Mooney Mite Series M-13  
Service Bulletin No. 14

MOONEY AIRCRAFT, INC.  
M-18 SERVICE LETTER NO. 15

M-18 SERVICE LETTER NO. 16

M-18 SERVICE LETTER NO. (17)

FIG. 4

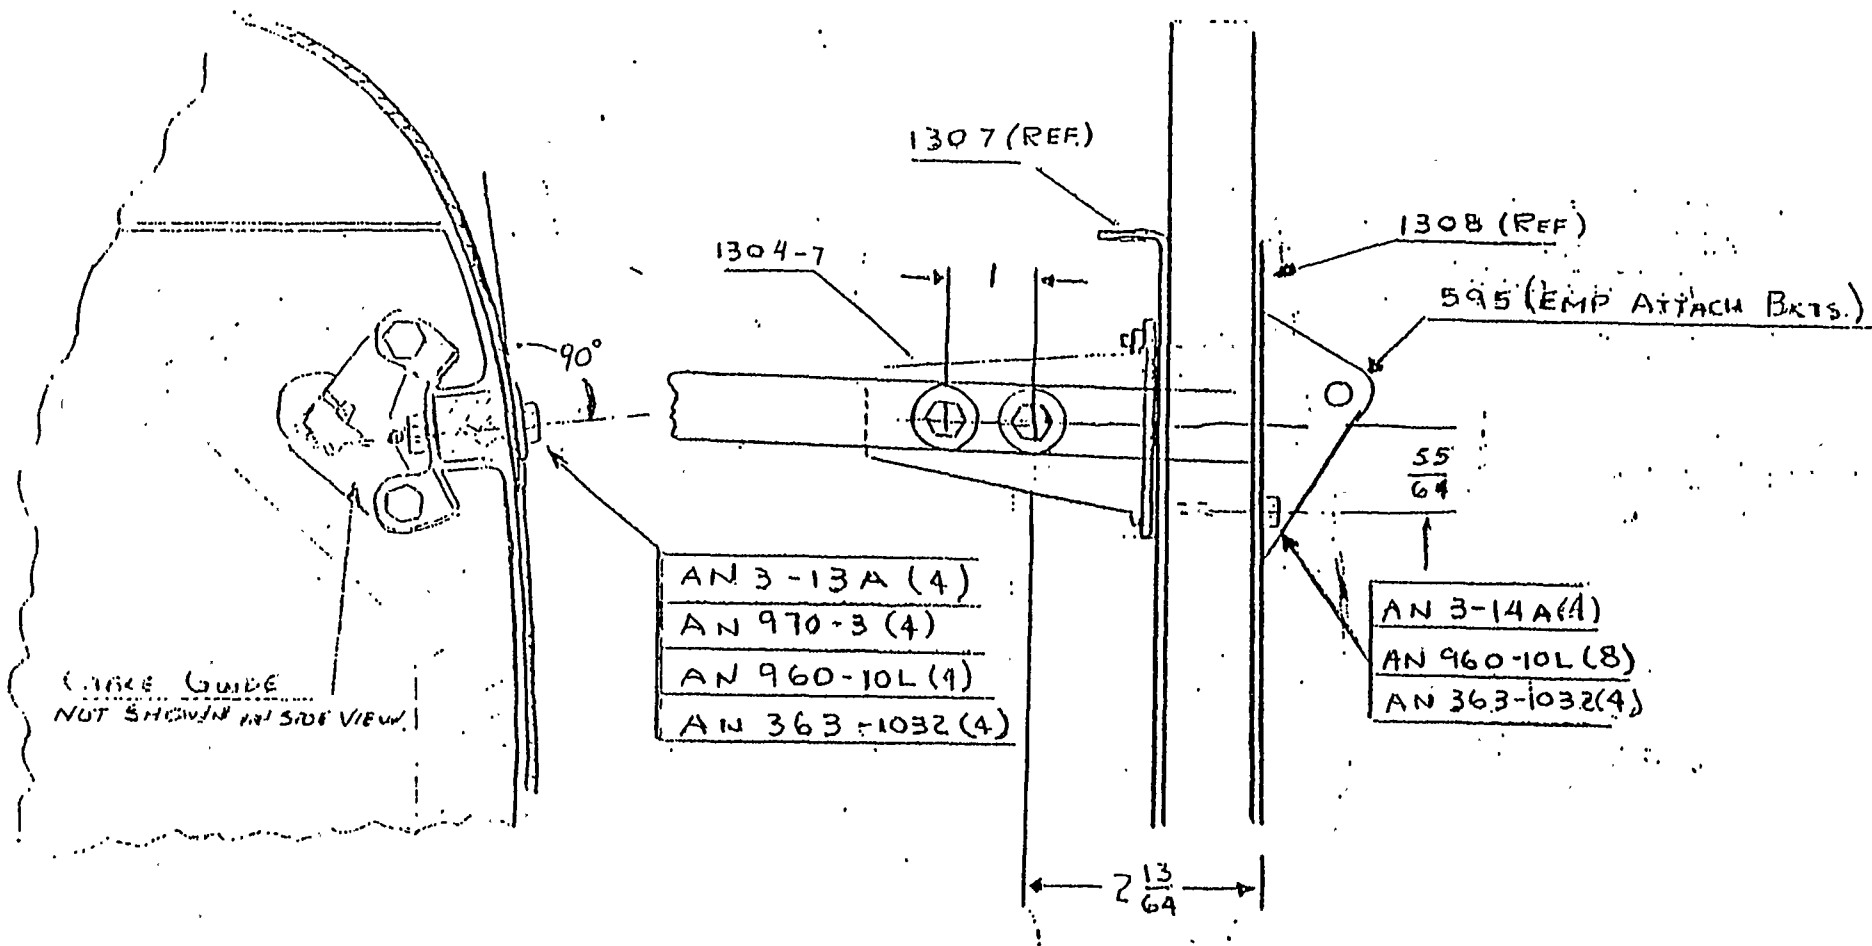
1. For all airplanes not having P/N 1157-1/-2 clips installed, the following must be accomplished after compliance with Part B:
  - a. Mark the location on the outside of tail cone of the four holes through the upper longeron as shown on Figure 4.

- c. Install P/N 1309-7/-8 fittings, empennage attachment brackets and cable guides as shown in Figure 4.
  - d. Block fittings to prevent play and, using 1/8 diameter holes as guides, drill 11/64 diameter holes (4) through longerons and 1309 fittings. Using 11/64 diameter holes as guides, drill out holes to 3/16 diameter.

- e. Bolt the 1309-7/-8 fittings to the longerons as shown in Figure 4. Exercise care in tightening bolts so as not to crush wood.

FIG 5

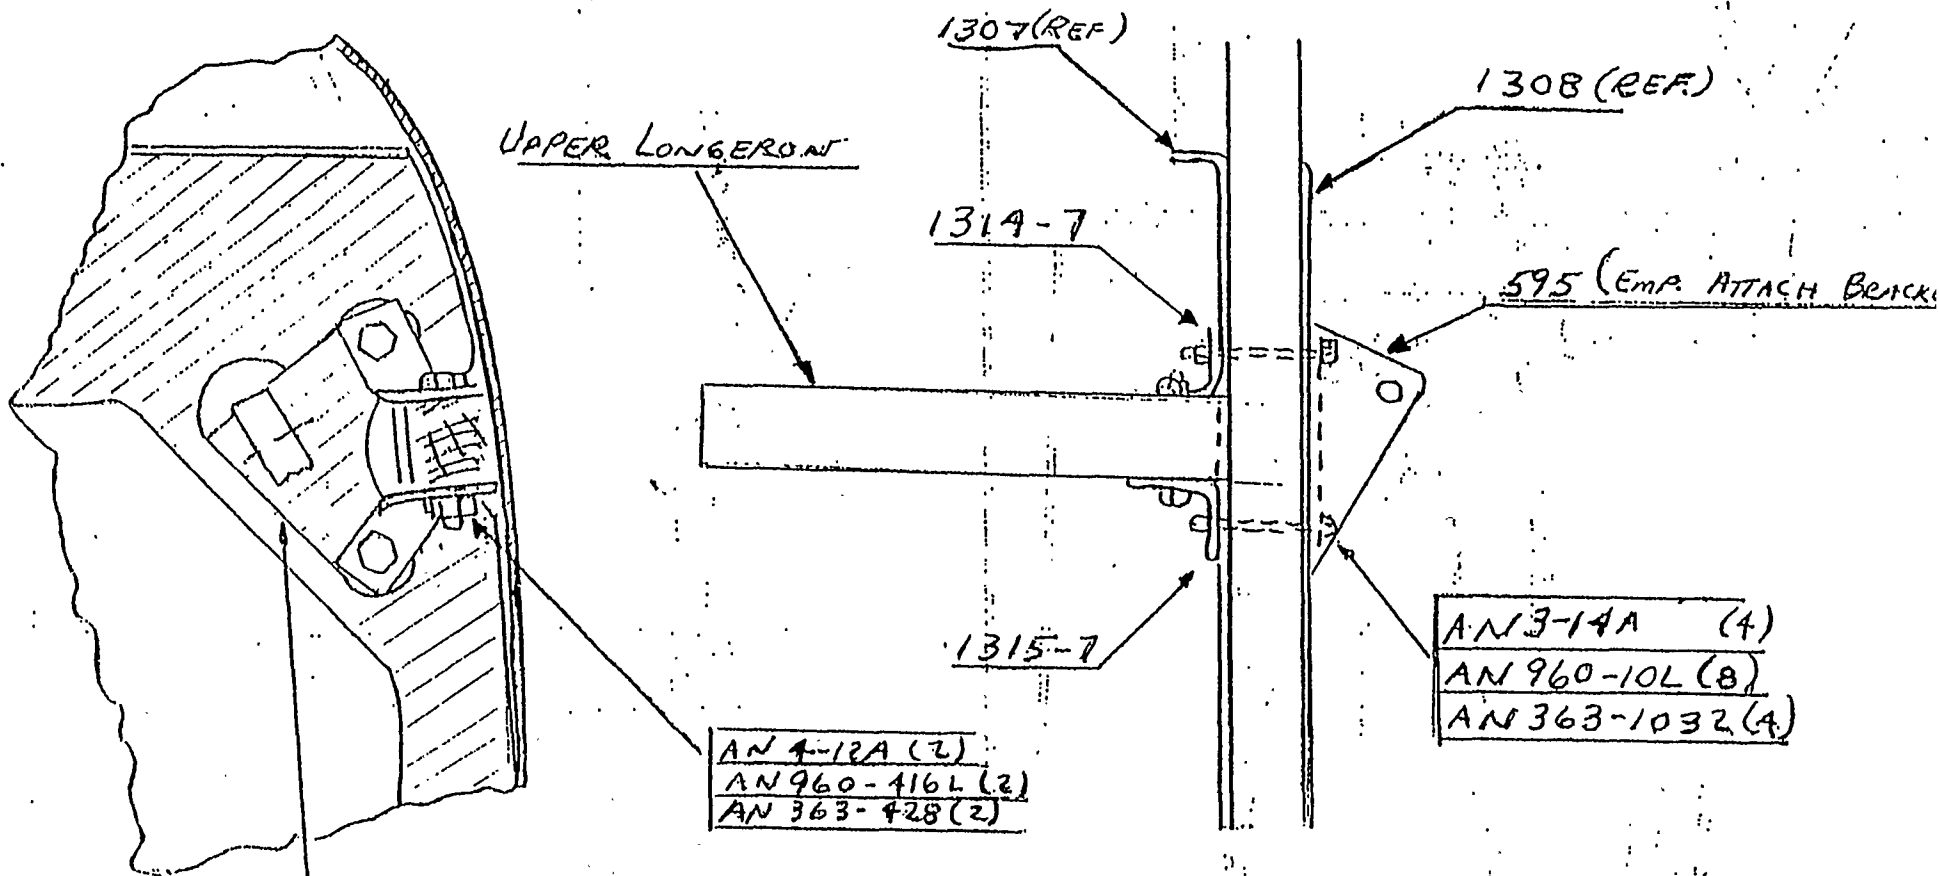
1. For airplanes which had P/N 1157-1/-2 clips installed and which have been reworked in accordance with Part E, the following shall be accomplished:
  - a. Reinstall empennage attachment brackets and cable guides and replace P/N 1157-1/-2 clips with P/N 1314-7/-8 clips and add P/N 1315-7/-8 clips on lower side of upper longeron picking up lower bolt of empennage attachment brackets as shown in Figure 5. Install vertical bolt through two clips and longeron as shown.

FIG. 6

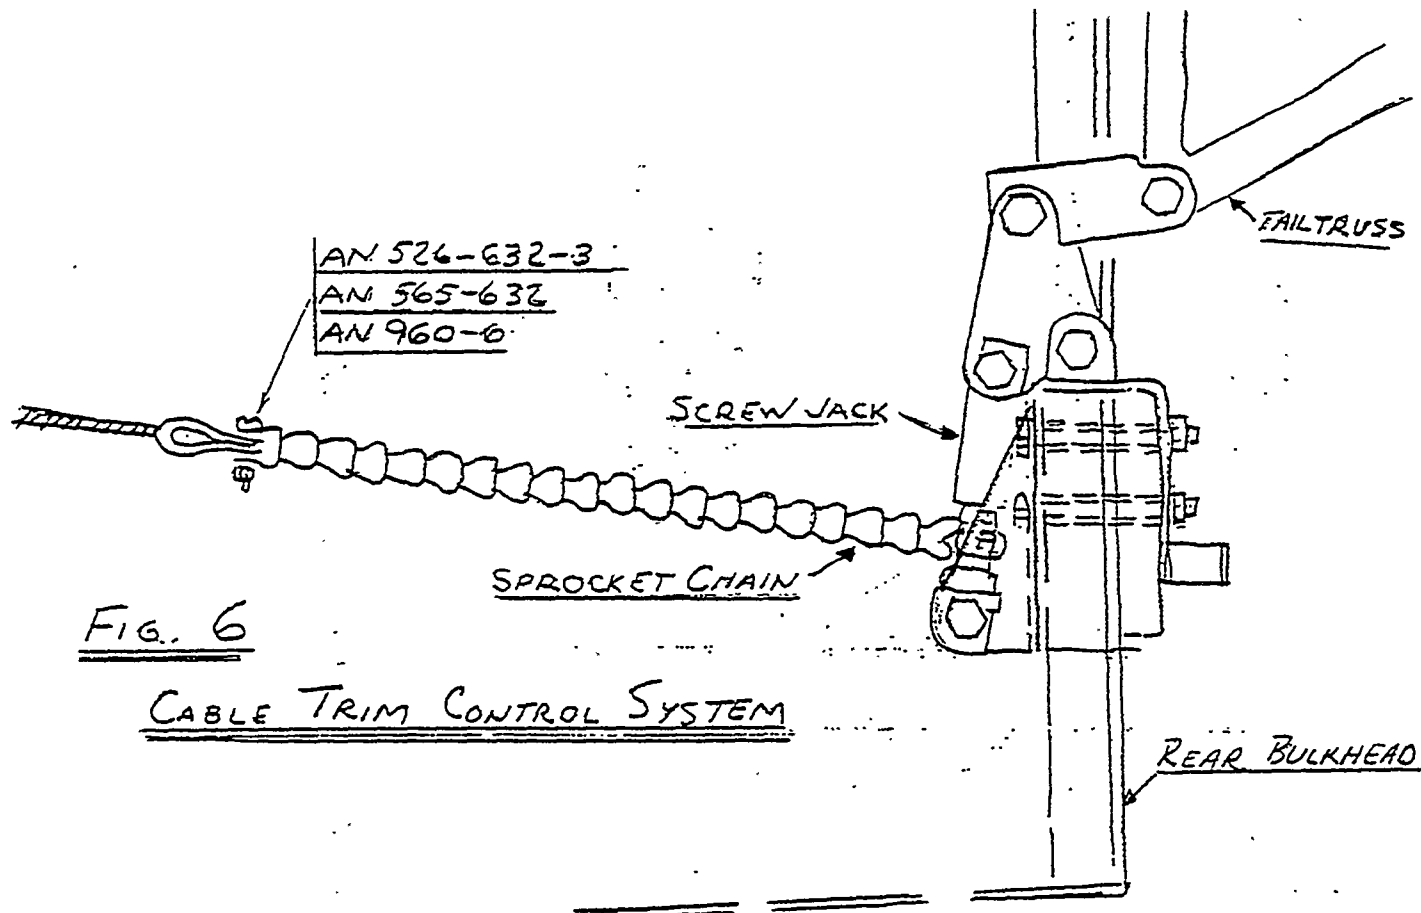
- (3) For airplanes equipped with a cable control trim system, the adjustment is made as follows:
    - i. Remove chain from screwjack by removing bolt connecting sprocket chain to cable on one side. See Figure 6.

- ii. Turn screwjack at sprocket until the leading edge of vertical fin is inclined forward  $3.5^{\circ}$  to vertical reference.
    - iii. Reinstall chain around sprocket and connecting bolt to cable end.

- iv. Check "nose down" trim position for vertical fin leading edge inclination rearward of  $1.5^{\circ}$  to vertical reference.
  - (4) For airplanes equipped with push-pull rod trim control system forward of the rear bulkhead, the adjustment is made as follows:

FIG 7

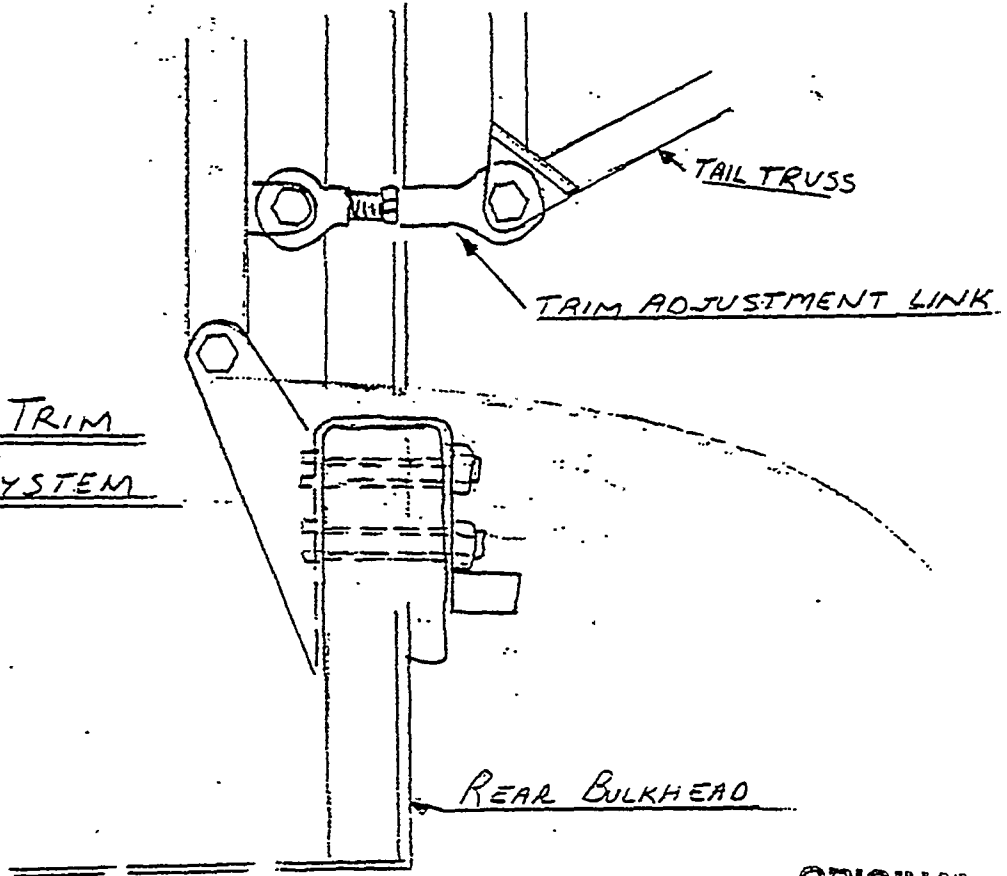
- i. Adjust heim bearing of trim adjustment link shown in Figure 7 until leading edge of vertical fin is inclined forward  $3.5^{\circ}$  with trim setting in "nose up" position.

- ii. Check inclination of leading edge of vertical fin for  $1.5^{\circ}$  rearward for trim in "nose down" position.
